**DEPARTMENT OF TRANSPORTATION
STATE OF GEORGIA
REVISED PROJECT CONCEPT REPORT**

Project Type: Widening / Reconstruction P.I. Number: 751650
 GDOT District: District 7 County: Fulton
 Federal Route Number: N/A State Route Number: SR 961

The proposed change to the approved concept is the project termini. The new project limits would extend along Old Alabama Road from 2500 feet west of Nesbit Ferry Road to Buice Road. The project length is revised to 5.3 miles. The western project limit was revised from SR140 / Holcomb Bridge Road to the new project limit to begin at Nesbit Ferry Road, and the eastern project limit was revised from Jones Bridge Road to Buice Road. (The previous project limits for P.I. No. 751650, STP00-9408-00(003) extended from Holcomb Bridge to Jones Bridge Road. The previous project limits for P.I. No. 0008425, CSSTP-0008-00(425) extended from Jones Bridge to Buice Road)

Figure
1

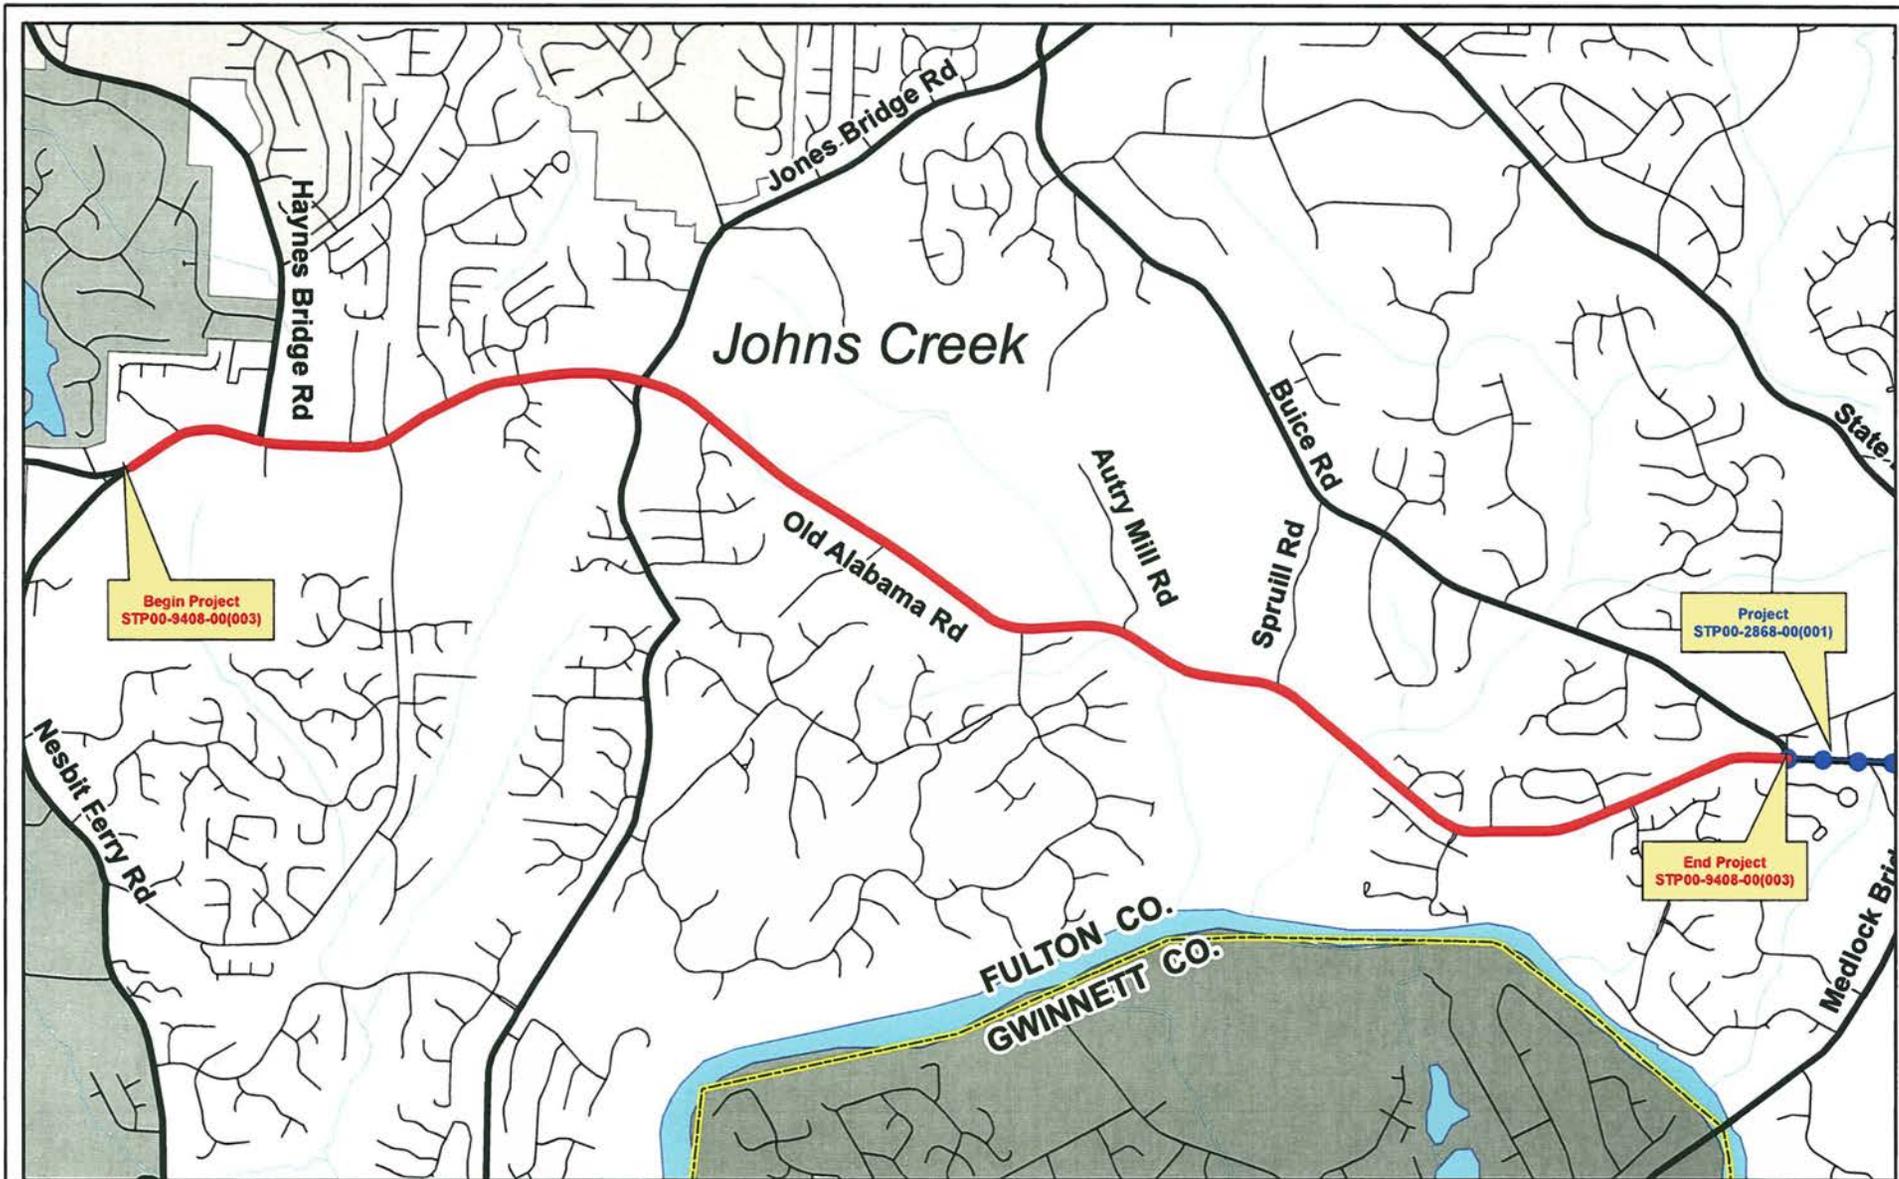
Approved Features:	Proposed Features:
<p>Project termini: 751650 – Old Alabama Road from the intersection with SR 140/Holcomb Bridge Road (mile log 0.0) to Jones Bridge Road (mile log 4.06). The project length is approximately 4.6 miles.</p> <p>0008425 – Old Alabama Road from the intersection with Jones Bridge Road (mile log 4.06) to Buice Road (mile log 7.52). The project length is approximately 3.4 miles.</p>	<p>Project termini: The western terminus of these projects is revised. The new project limits for PI 751650 would extend along Old Alabama Road from Nesbit Ferry Road (mile log 2.56) to Buice Road (mile log 7.52).</p> <p>Note that in order to tie into the existing roadway, the proposed project would begin 2,500 feet west of Nesbit Ferry Road.</p> <p>The proposed project length (including the west tie-in) would be approximately 5.4 miles.</p> <p>Project 008425 will be deleted from the program.</p>

<p>Reason(s) for change: The Nesbit Ferry Road intersection was chosen as the western terminus since there are no other projects planned along Old Alabama Road to the west of Nesbit Ferry Road in the foreseeable future. Even though the city of Roswell maintains a need for improvements to Old Alabama Road in their 2006 Transportation Master Plan, the Roswell city council passed a resolution opposing widening of Old Alabama Road west of the Old Alabama Connector. In 2010, city of Roswell representatives requested that the GDOT remove the improvements to Old Alabama Road within the Roswell city limits (between Holcomb Bridge Road and near Woodfall Drive) from the Transportation Improvement Program (TIP). Also, even though the city of Roswell provided strong support for the intersection project to improve the Old Alabama Connector and Roxburgh Drive (Project HPP-0005-00(428), P.I. 0005428) throughout project studies, they ultimately did not secure Right of Way funds to construct the project.</p> <p>In addition, a Design Exception is required for the existing grades over 7%, located within the original PI #008425. The proposed profile would not change these grades in order to minimize impacts to adjacent properties and utilities. A Design Variance is required for the median width that is less than 20' per the Design Manual, also located within the original PI #008425. These reports will be addressed and submitted for approval under the updated project number.</p>
